7280 NEVADA LANE EL PASO COUNTY, COLORADO

GRADING AND EROSION CONTROL PLANS

PCD FILING NO. : PPR-2411

LEVEL SPREADER SECTION C-C
SCALE: N.T.S.

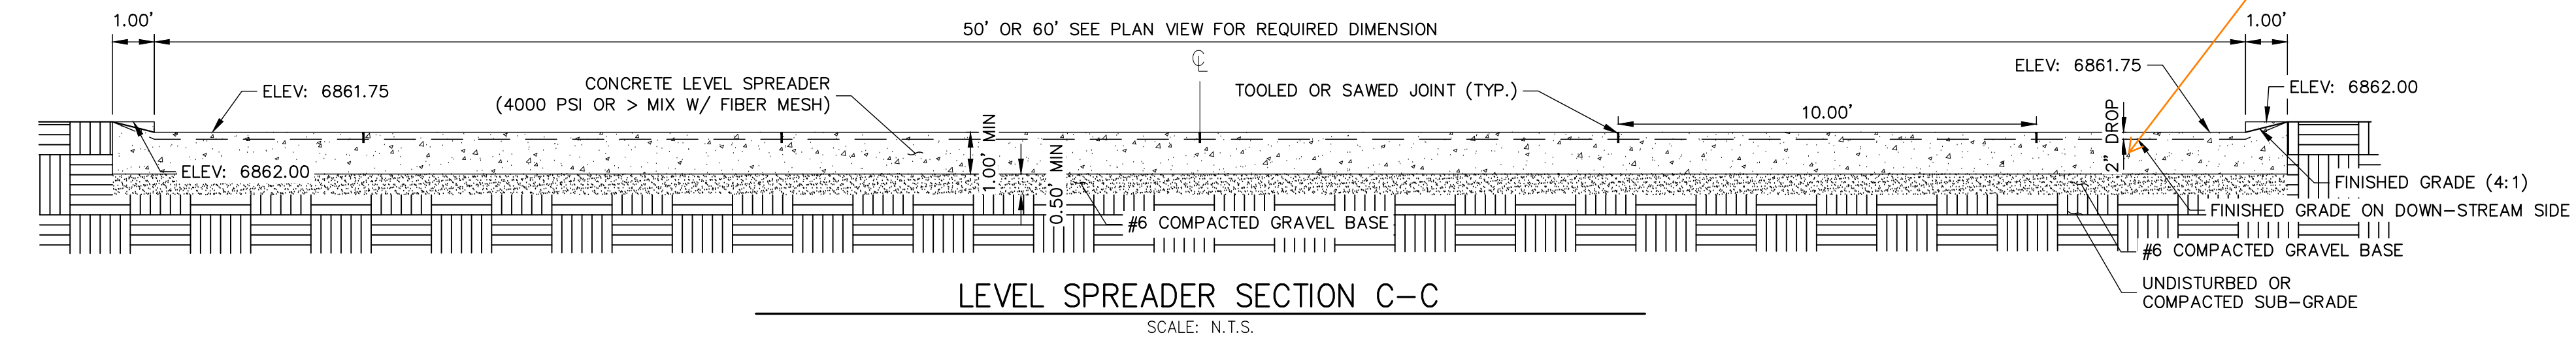
Note that MHFD's latest RR guidance (March 2024) recommends a min 3" vertical drop. But I understand if this site is too flat to accommodate this.
